DOCKET NO. 48745 SOAH DOCKET 473-19-1841

COMPLIANCE FILING OF ENTERGY	§	BEFORE THE STATE OFFIC
TEXAS, INC. RELATING TO	§	
PARTICIPATION IN SMART METER	§	\mathbf{OF}
TEXAS AND CHANGES TO ITS	§	
ADVANCED METERING SYSTEM	§	ADMINISTRATIVE HEARINGS

RESPONSE OF ENTERGY TEXAS, INC. TO MISSION: DATA COALITION THIRD REQUEST FOR INFORMATION: MISSION: DATA COALITION 3: 1, 2, 3, 4

Green Button Connect Customer List

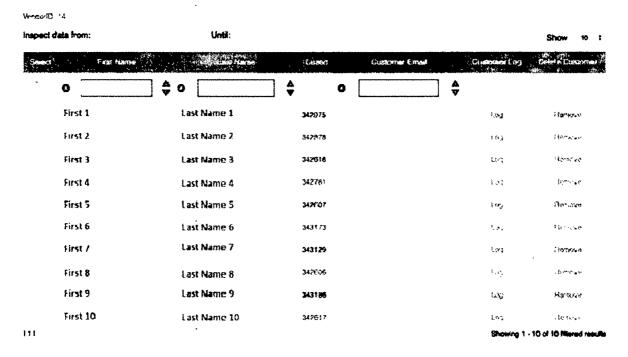
- a. Is the XML file referenced separate from, or contained within, the Green Button file containing usage data?
- b. How will the "unique identifier" be "provided to an authorized CSP"? Via email, File Transfer Protocol site, Application Programming Interface, or other method? Please explain in detail.
- c. Please provide a sample of the XML file containing the unique identifiers.
- d. Please explain in detail how a CSP is expected to use a "unique identifier" to determine the meter's address or physical location.

- a. The unique identifier is contained in the Green Button XML file along with the usage data. The unique identifier will appear in the "Account:XXXXXX" field in the sample file provided in response to subpart c.
- b. A CSP will be able to access the unique identifier via the ETI Customer Engagement Portal (CEP). See the response to subpart d for an illustrative screen shot.
- c. See attached file (My Data –accnt numXXXX.xml), which is illustrative and subject to modification during the Green Button Alliance certification process. A customer's unique identifier would appear in the "Account:XXXXXX" field.

d. An authorized CSP will have access to the unique identifier and other customer data, including meter location, via the CEP. See the following screen shot, which is illustrative and subject to modification during final design. The column labeled "CustID" will contain the customer's unique identifier. In addition, there will either be a separate column with the meter location or the ability to click on a customer's name to display the meter location.
